Process Sheet

Drawing Name: PANEL-350 UPPER BULKHEAD

Part Number: D36553

From: Chris Provencal [cprovencal@dartaero.com]
Sent: April 24, 2008 8:57 AM
To: Peter Hum
Subject: FW: NCR D3655-3

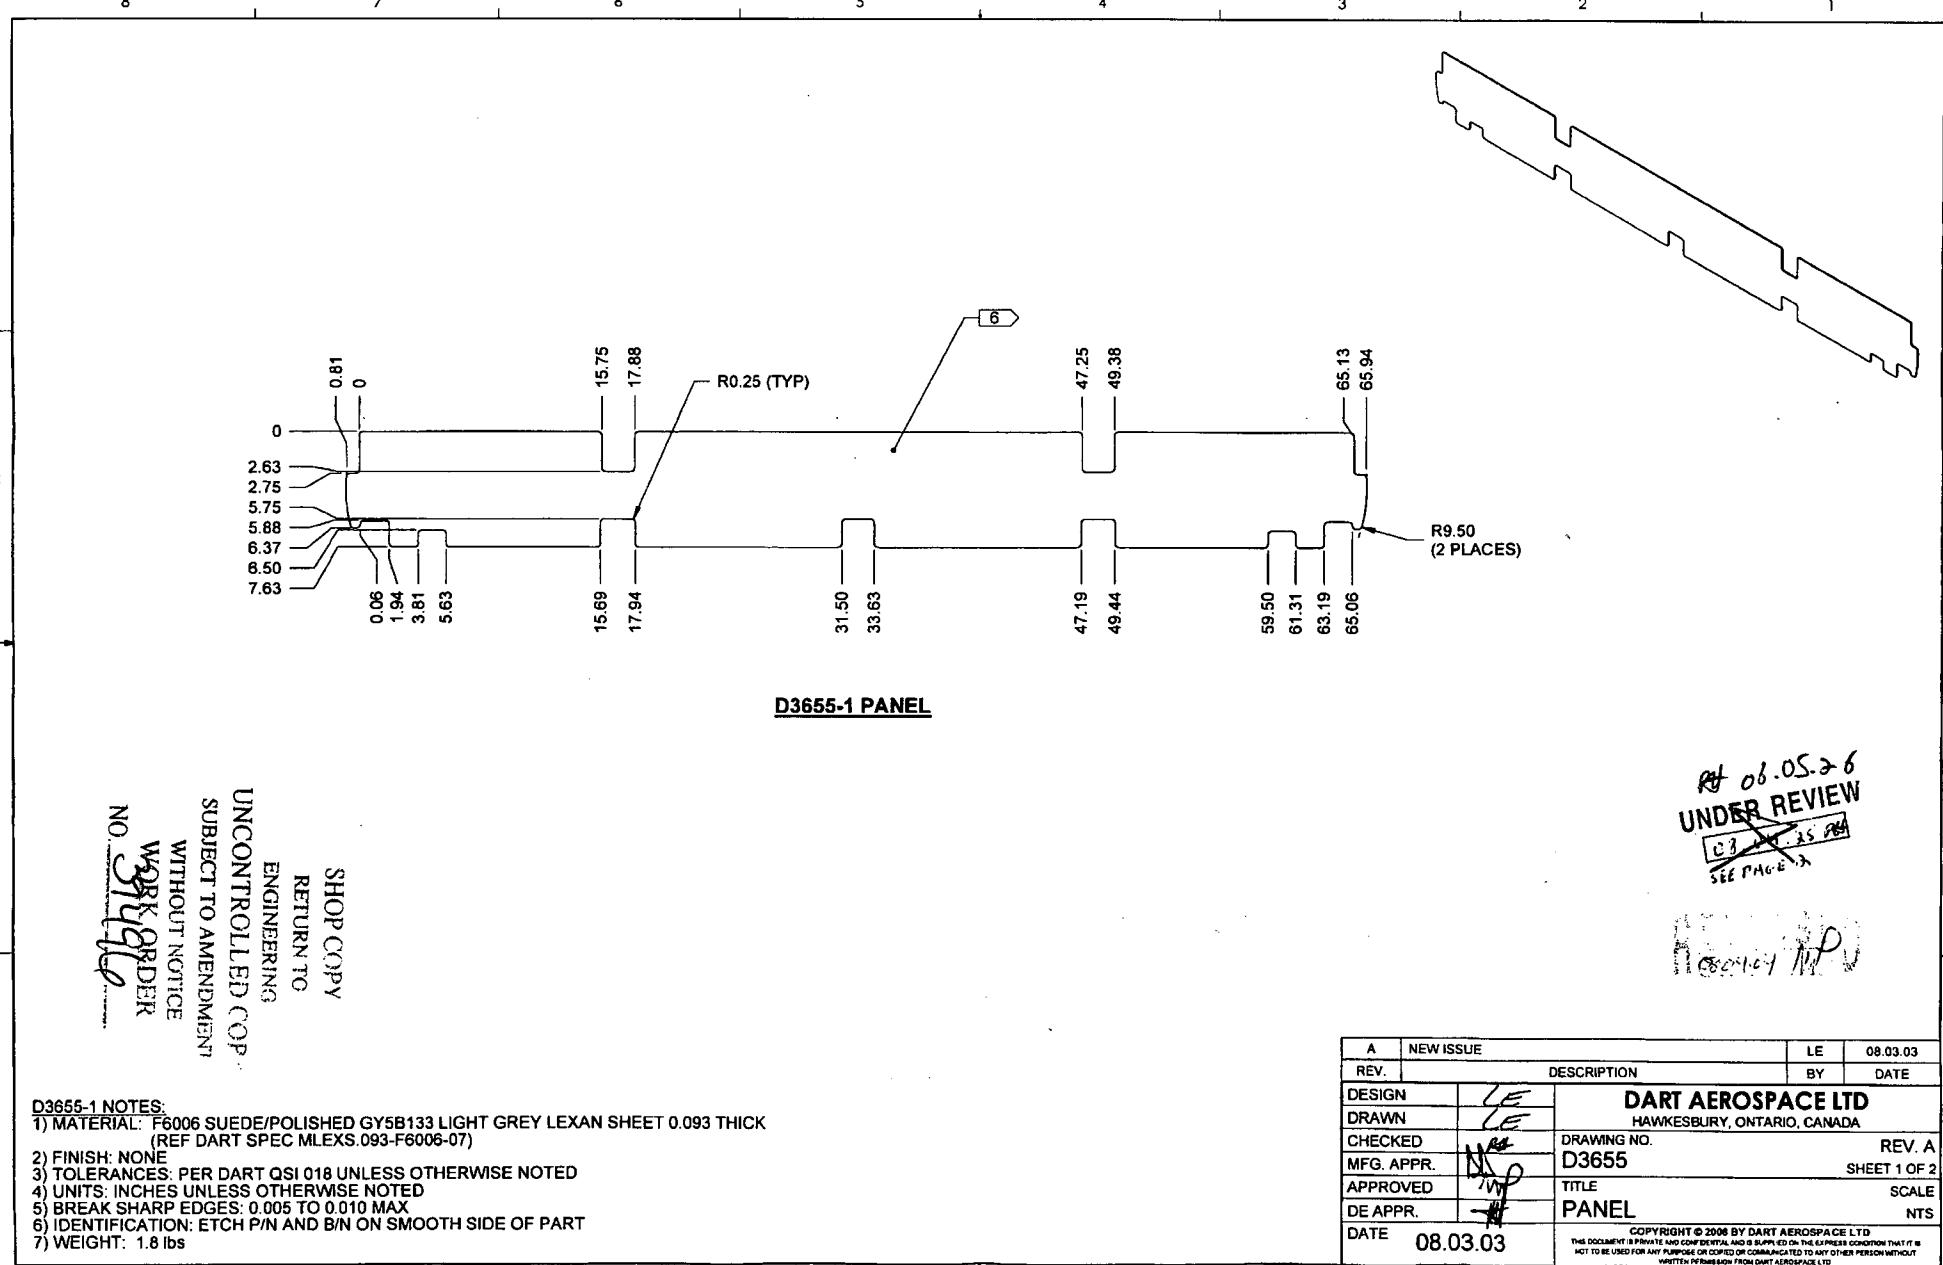
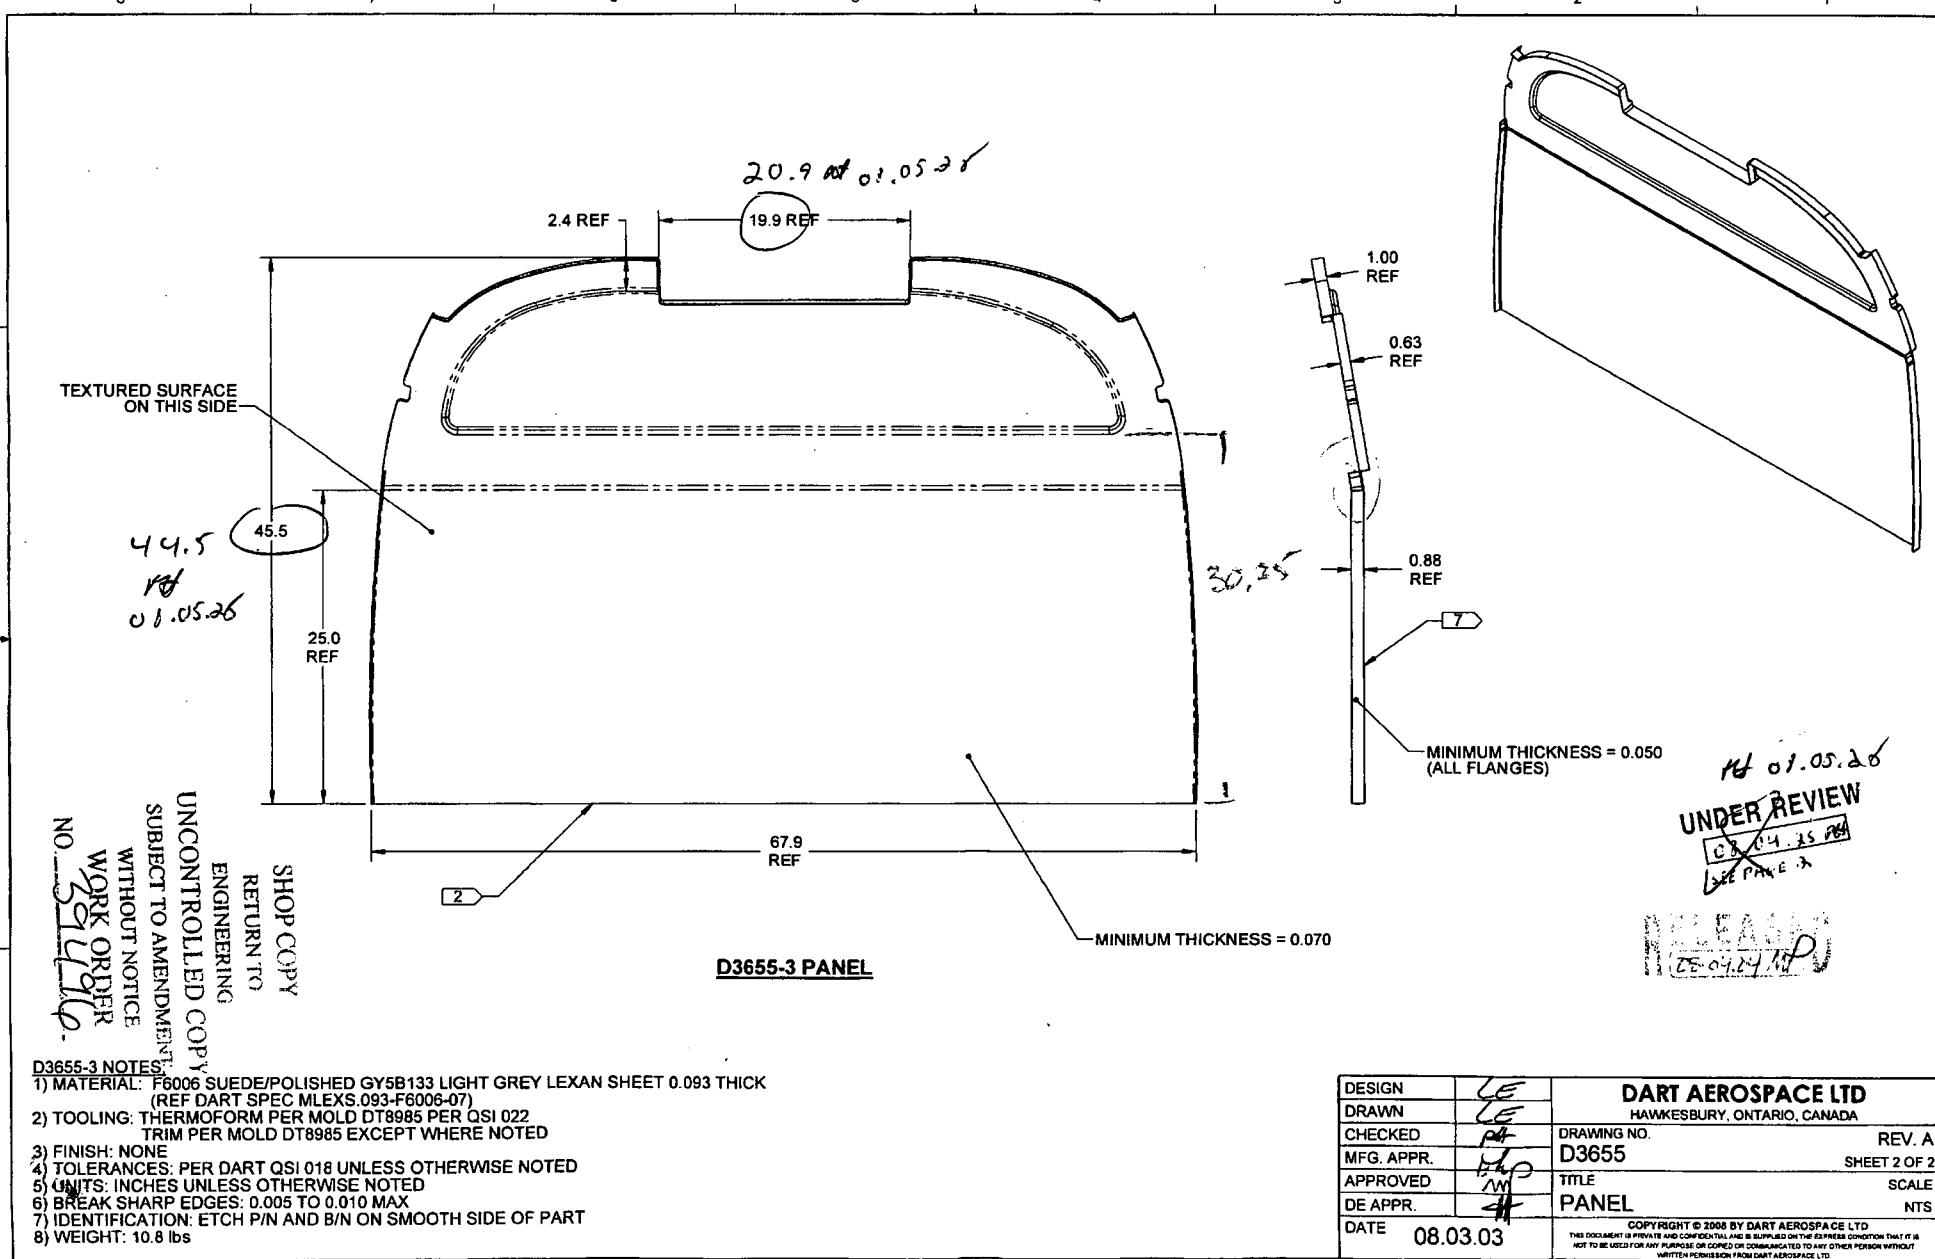
NCR: <u>39496</u>		WORK ORDER NON-CONFORMANCE (NCR)						
DATE	STEP	Description of NC Section A	Corrective Action Section B			Verification Section C	Approval Chief Eng	Approval QC Inspector
			Initial Chief Eng	Action Description Chief Eng	Sign & Date			
<u>08.05.06</u>	<u>6</u>	<u>DIMs 19.9 and 45.5 are 20.9 and 44.5</u>	<u>PF 08.05.06</u>	<u>ACCEPTABLE DEVIATION (SEE ATTACHED)</u>	<u>W</u>	<u>08/06/06</u>	<u>PF 08.05.06</u>	<u>S</u>

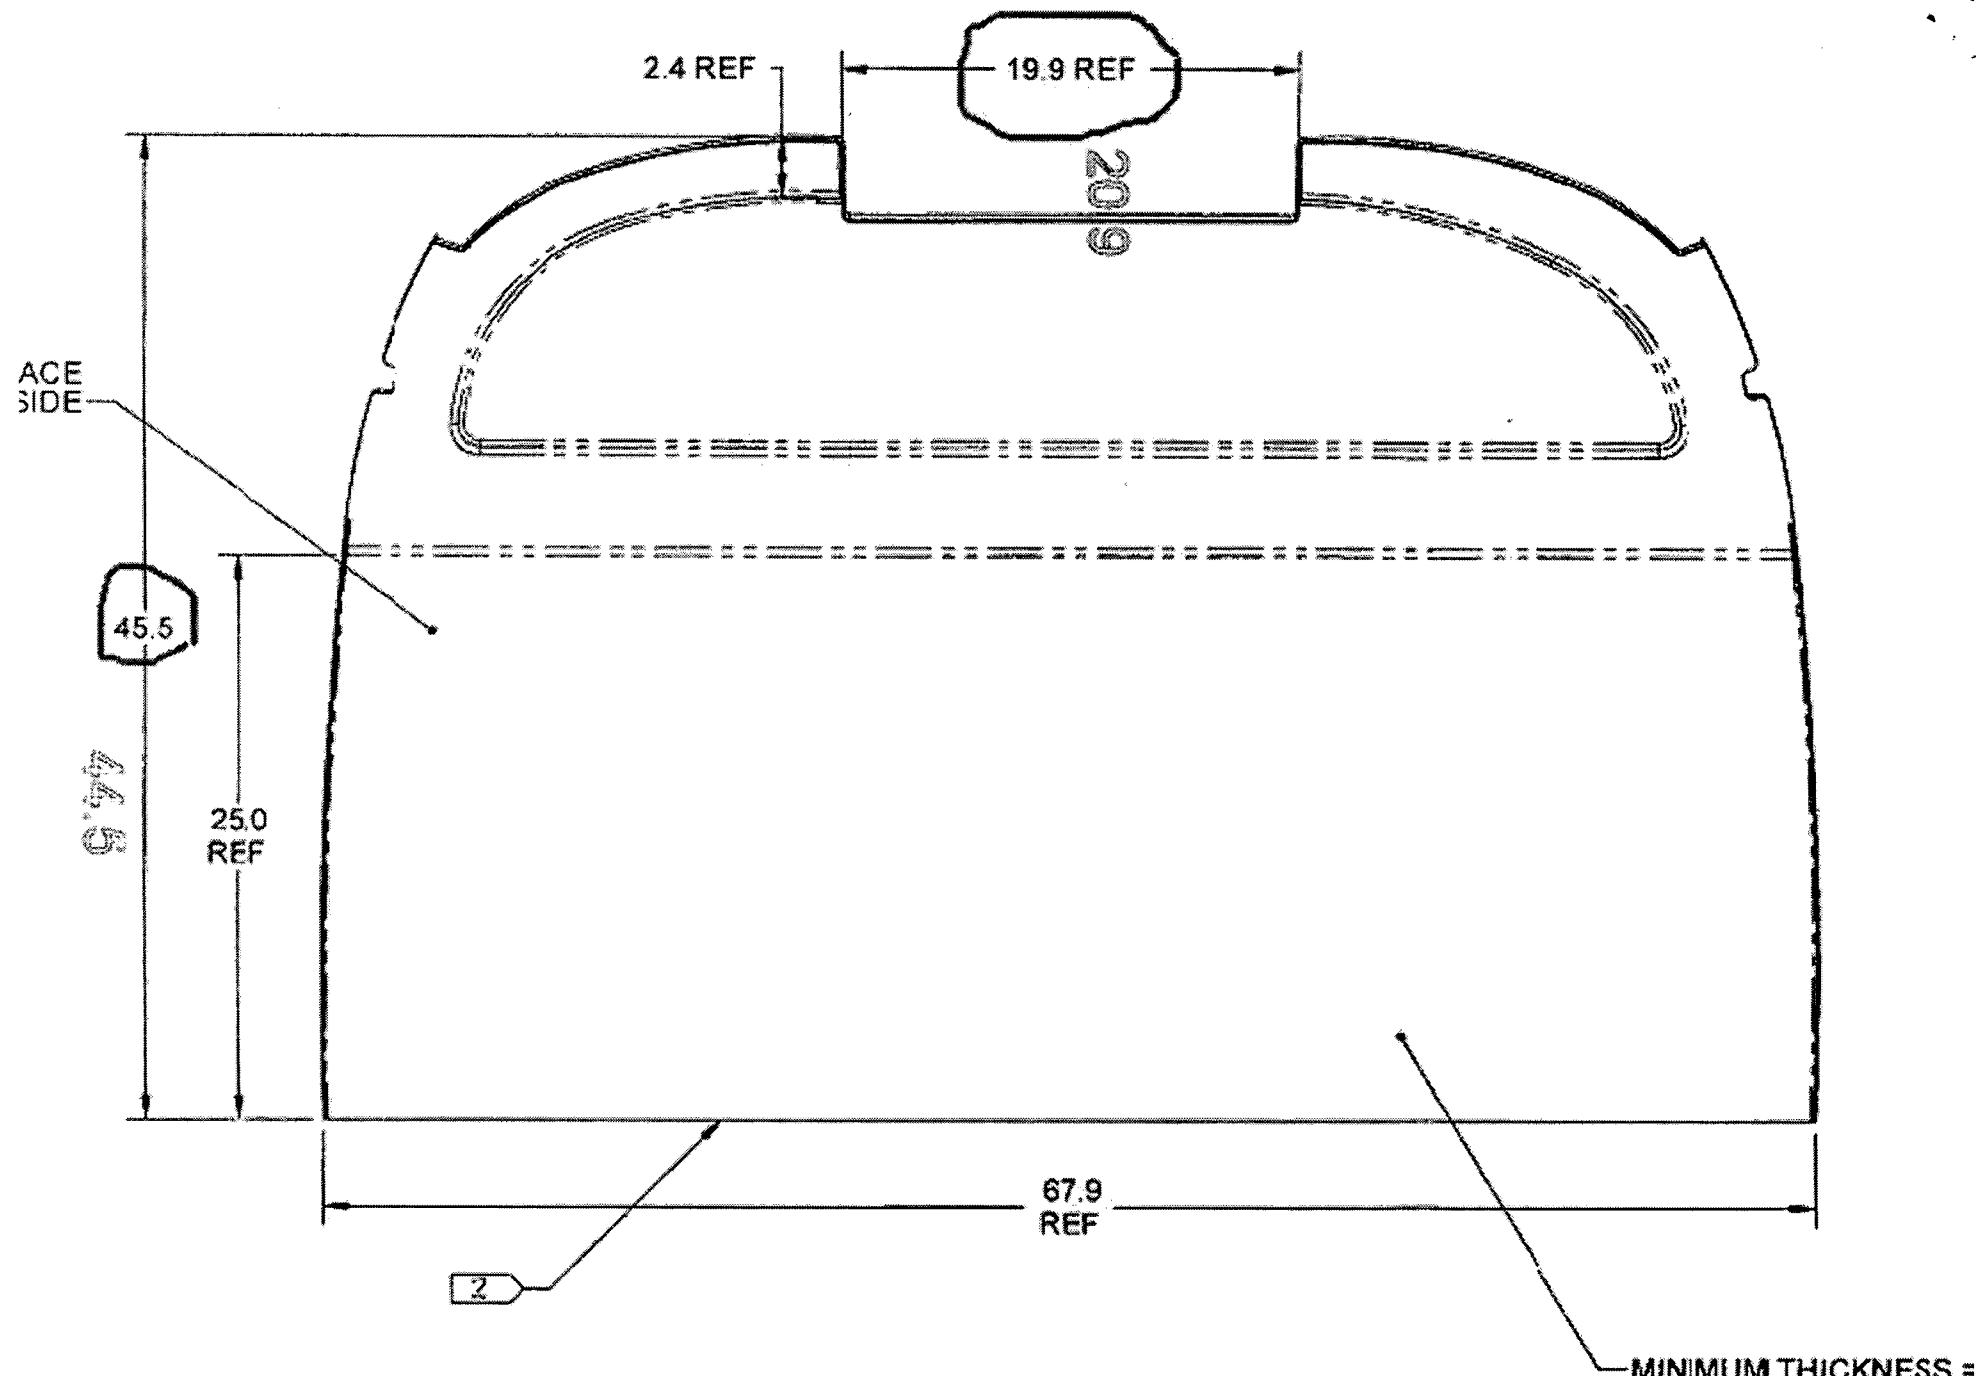
For the D3655-3 Panel (350 interiors), the dwg dimension 19.9" is 20.9", dwg dimension 45.5" is 44.5". Ref attached pic. The part was made to the mold. The dwg was evidently created before the mold, and the dimensions were never updated.

The 20.9" width of the 'slot' fits with the mating part correctly; 19.9" would be too small and would have a sloppy fit. A verified this myself.

The dwg length of 45.5" is impossible to achieve from the mold. Daryl made the part as long as possible. The parts have evidently been fit into the aircraft and I'm told this dim works.

The dwg obviously needs an update. In the meantime, can we accept this deviation?

If the parts match what is in the aircraft, they will be acceptable. But I don't think we should make any more without doing a PROPER FAI and checking against the drawing.
